ARCHITECT'S SUPPLEMENTAL INSTRUCTIONS

PROJECT:	The Reserves at Magnolia New Apartment Complex Denton, TX	Report No.	One (1)
OWNER:	Overland Property Group Dan Maximuk 234 N. Santa Fe Ave, Suite A Salina, KS 67401	Date	Oct. 22, 2024
CONTRACTOR:	Snyder Construction Group 4820 N. Town Centre Dr. Ozark, MO 65721	Architect's Proj No.	21-3205
		Contract For:	General Construction Mechanical, Electrical

Please Note: Drawings and Specification Edits associated with this ASI are dated as **7-17-2024**. This date above is the date this ASI was issued.

A7.4

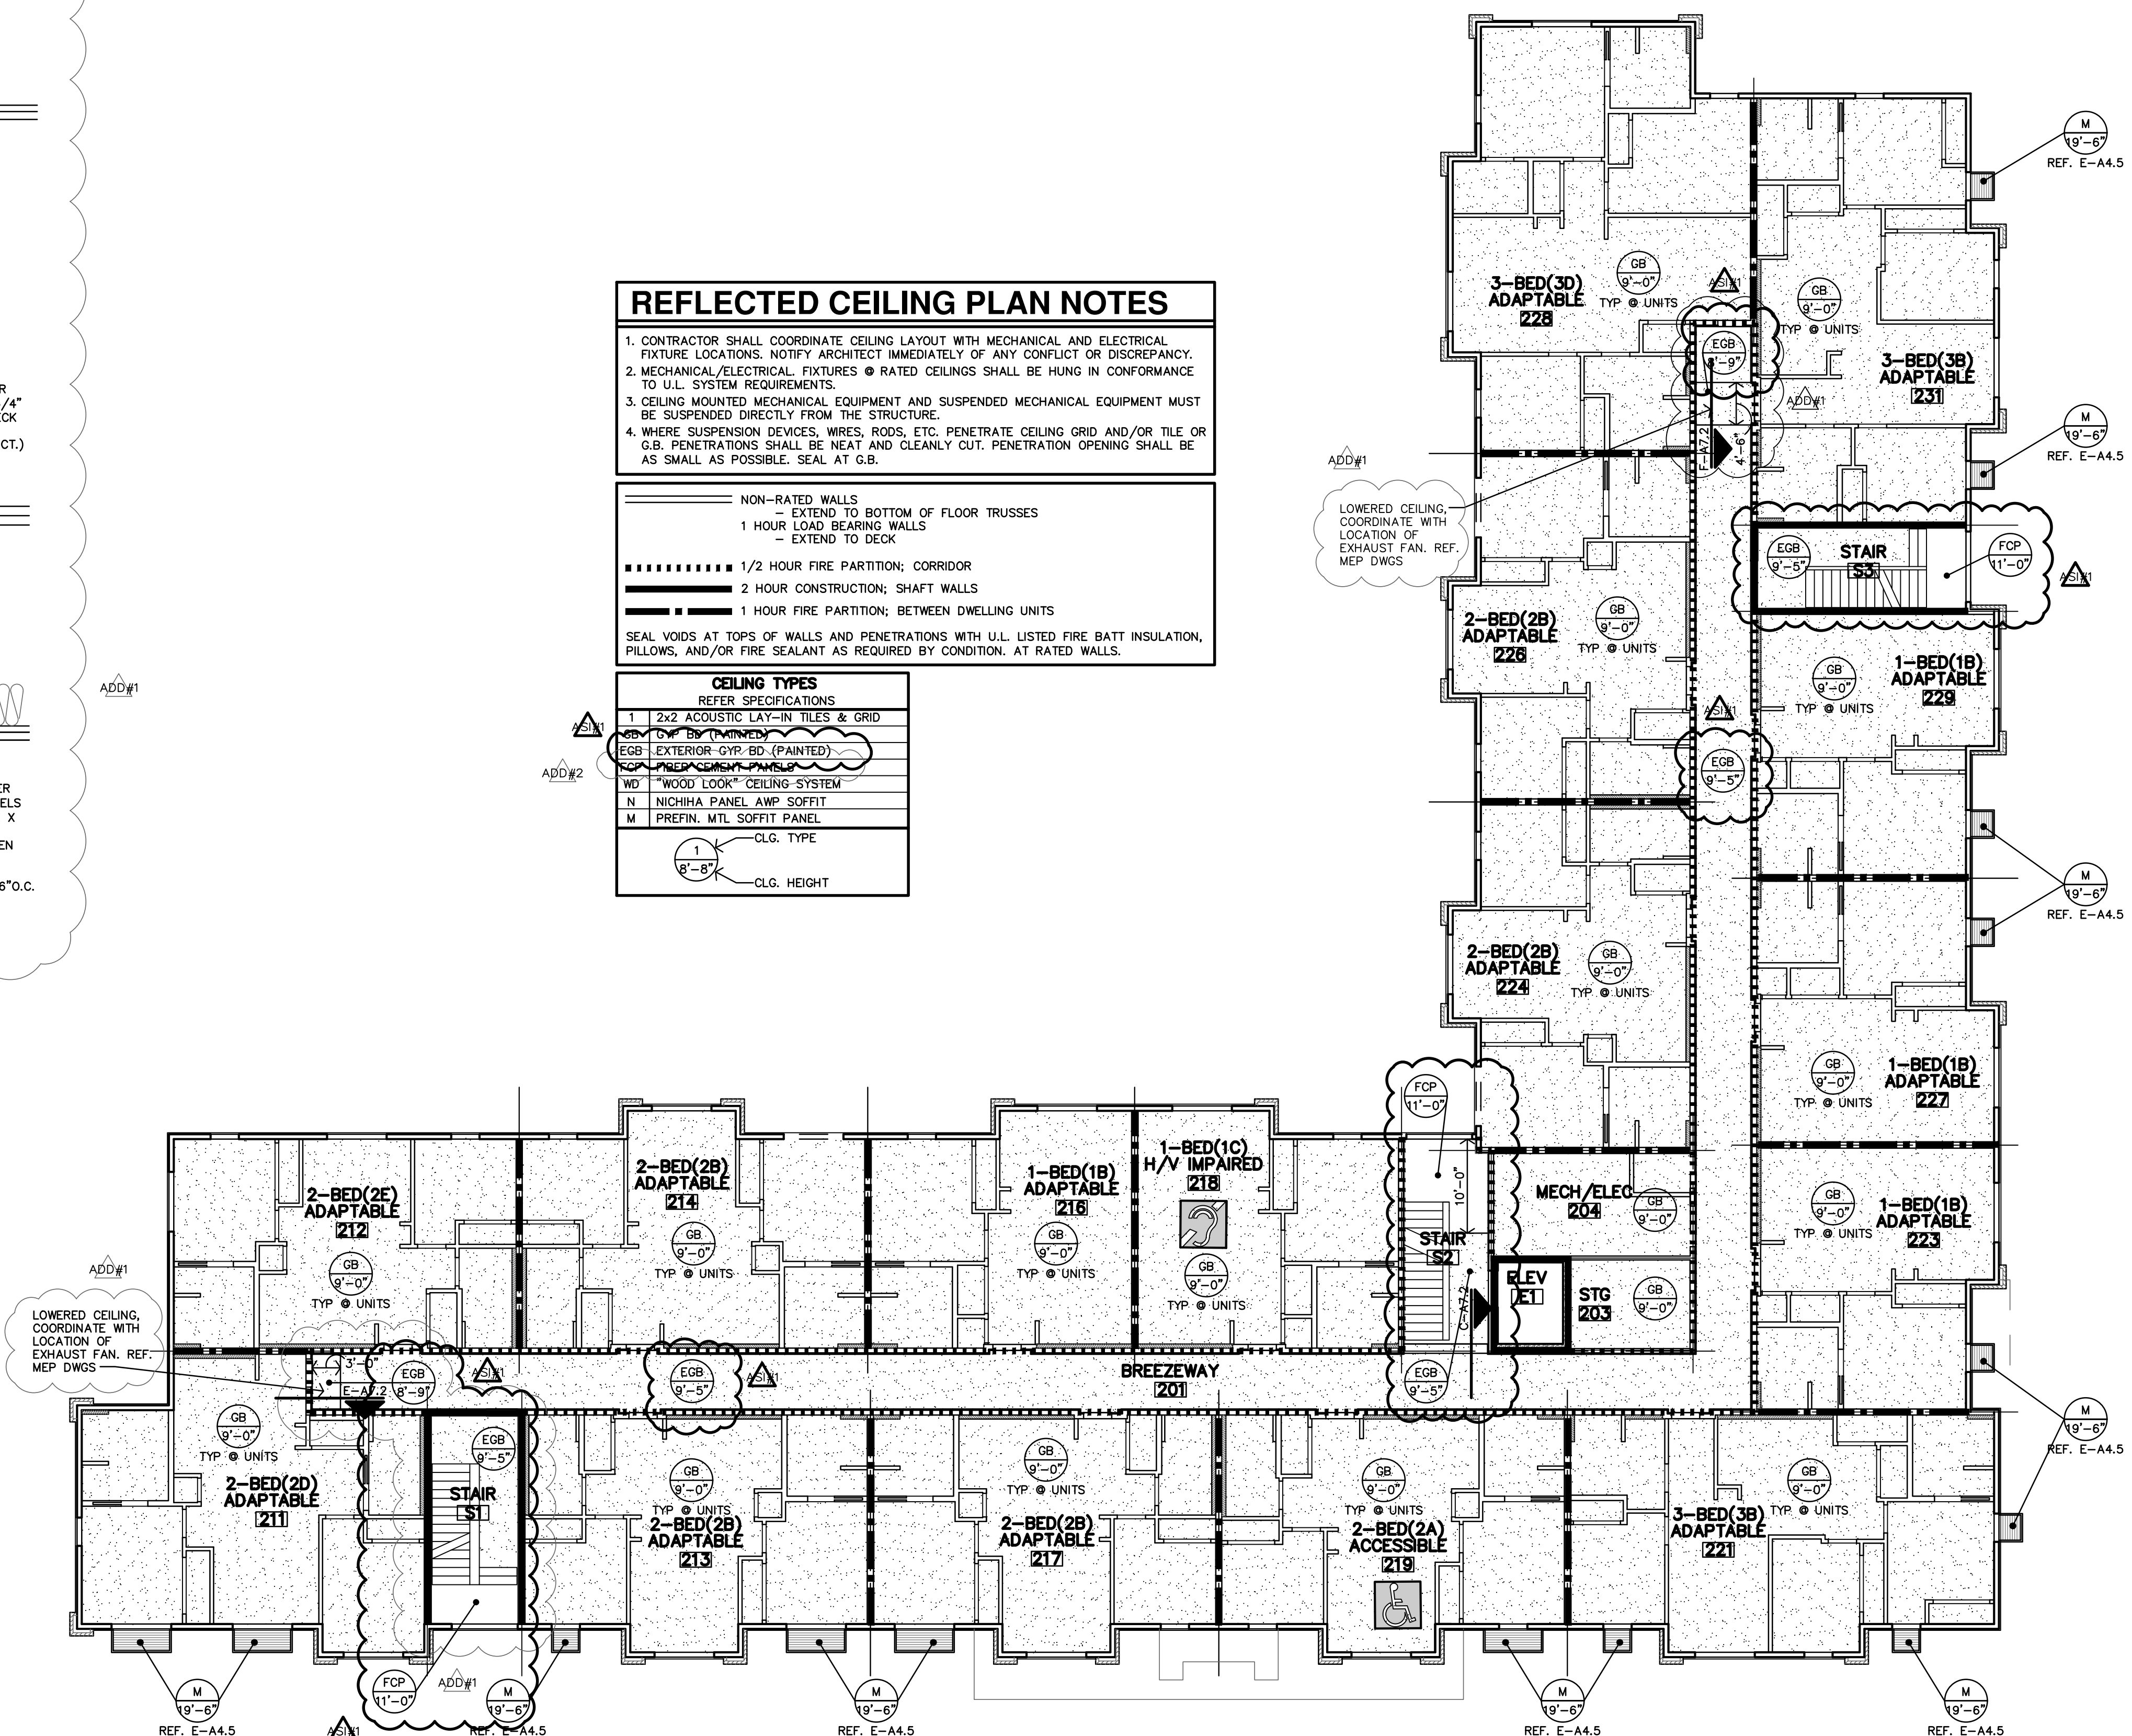
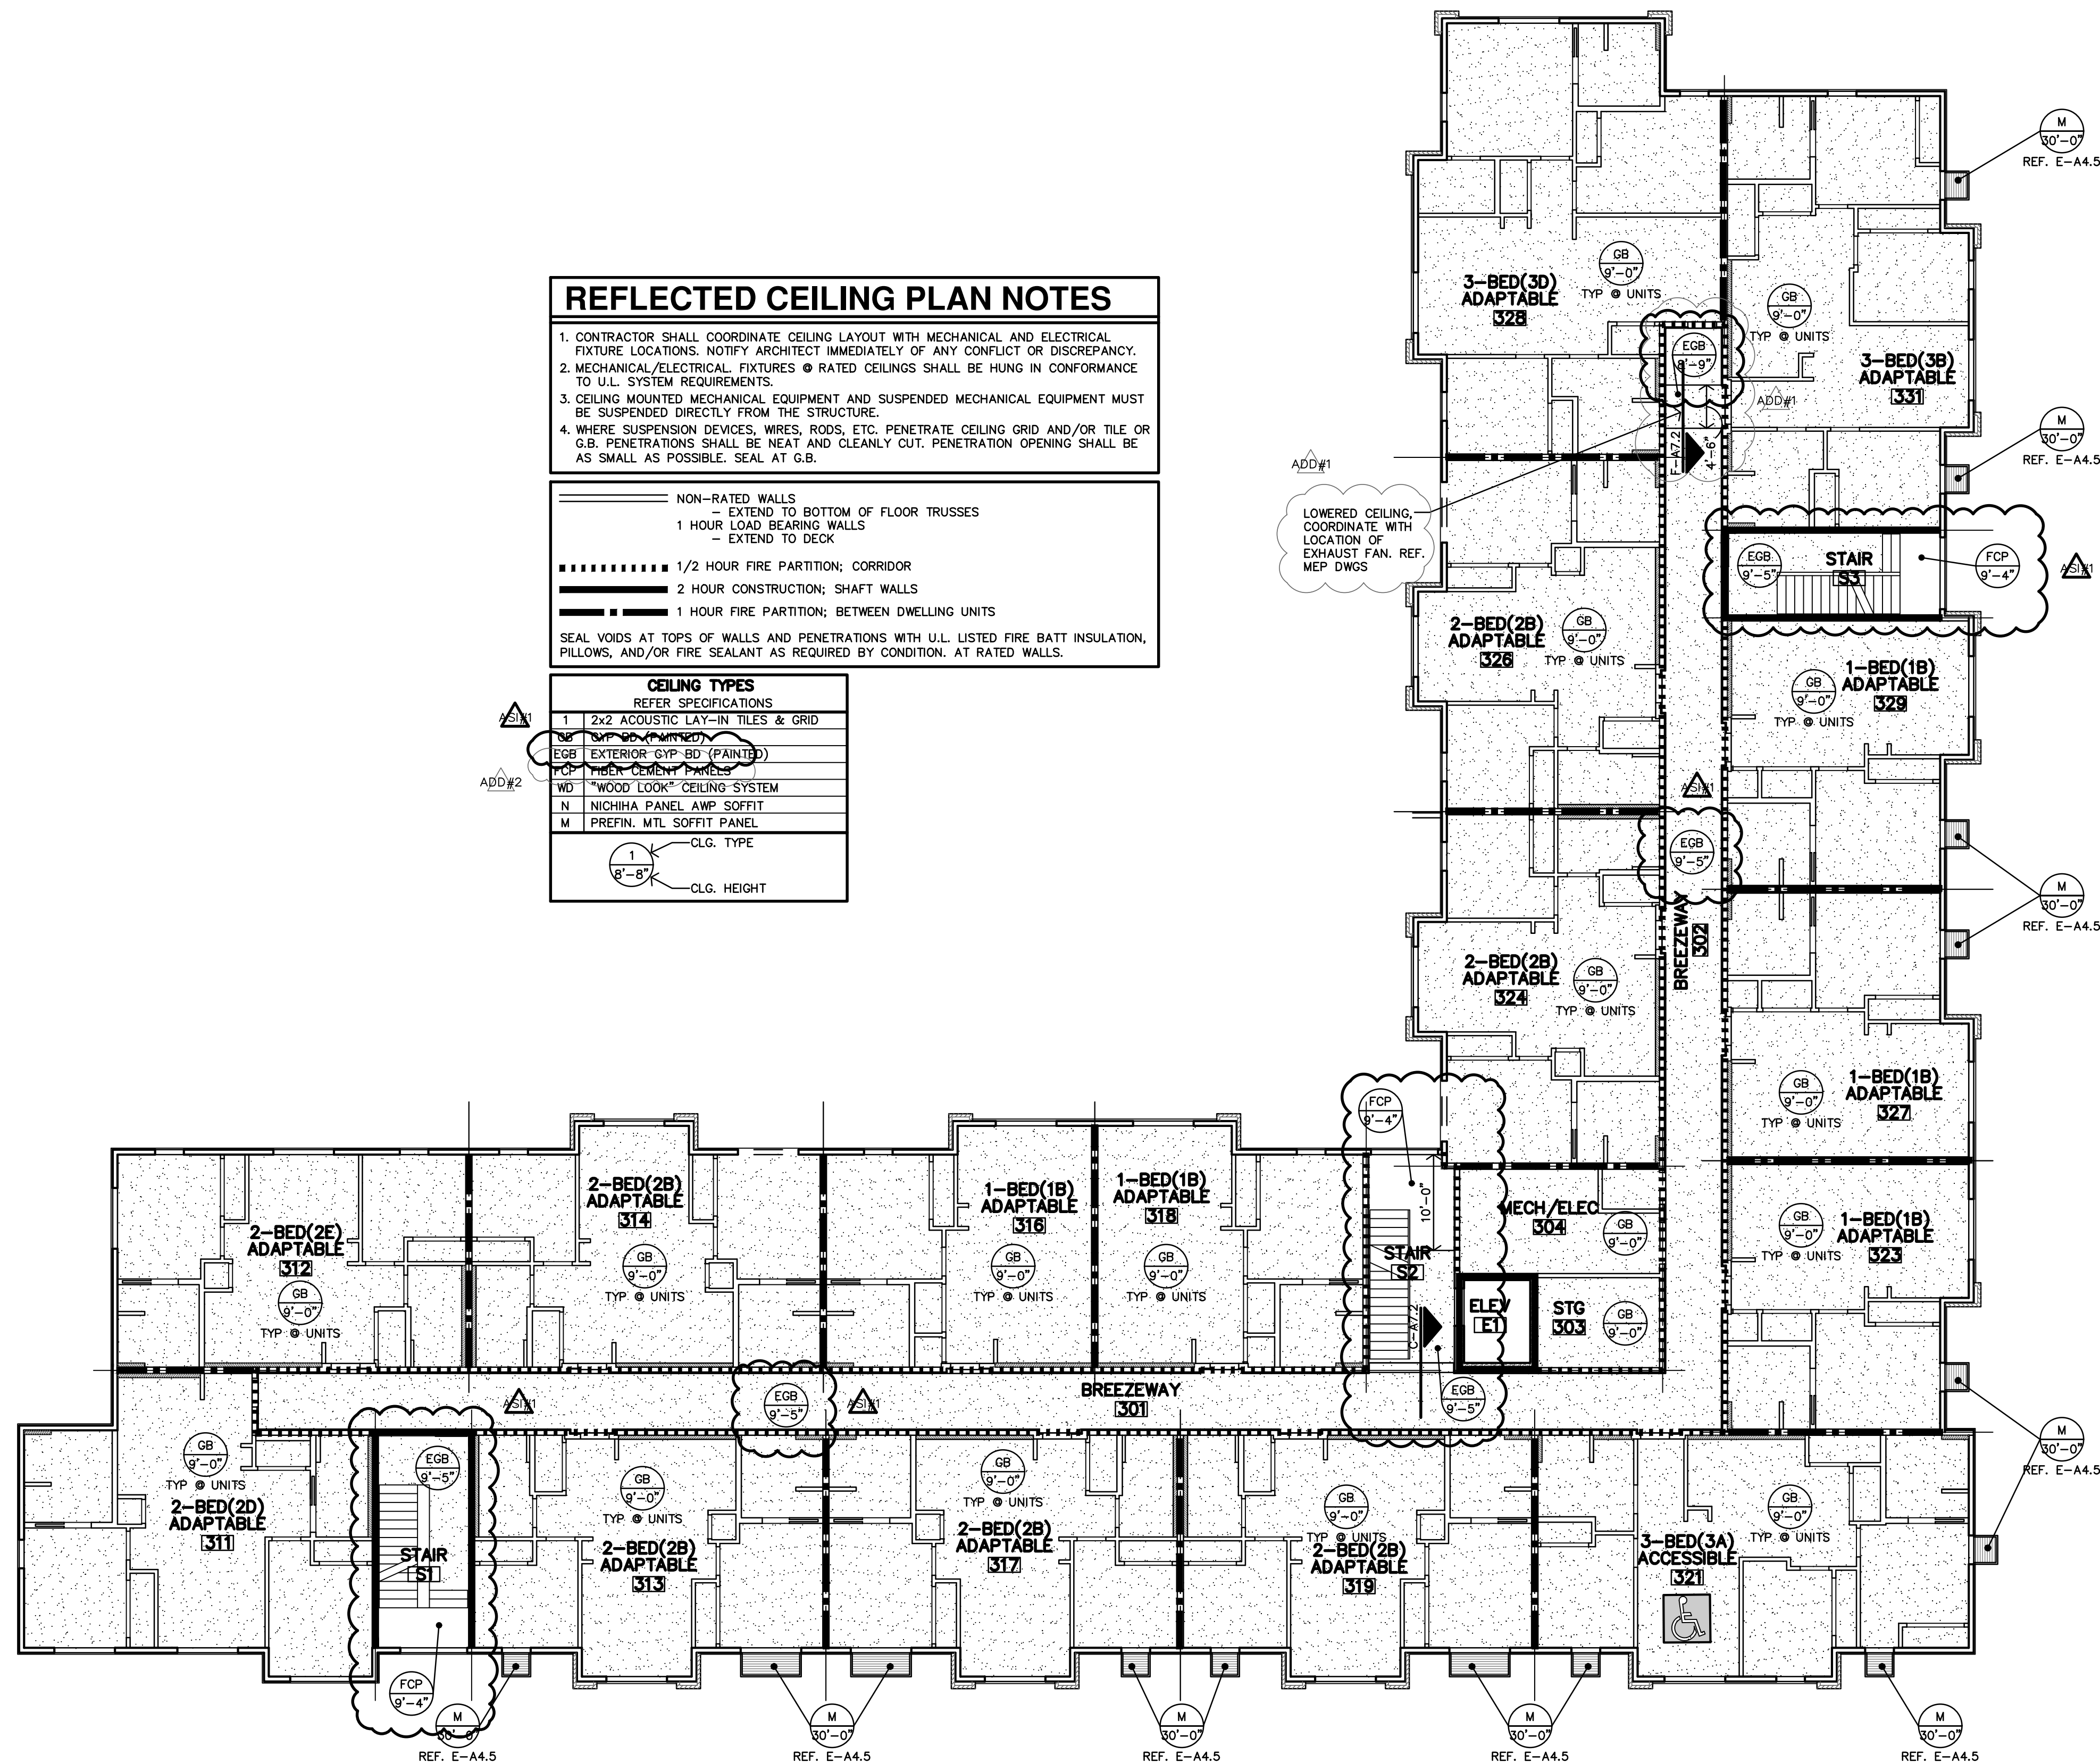
- 15) Utilize 5/8" type 'x' exterior-grade gypsum board finish at exterior breezeways in lieu of fiber cement siding and soffit. (VE Item #19) Exception: within 10 feet of each exterior opening. At these areas, fiber cement panel and trim shall be used. Reference revised details on Sheets A2.0, A3.3, A4.1, A4.6, A4.7, A4.8, A6.1, A6.2, A6.3, A7.1, A7.2, A7.3, and A7.4
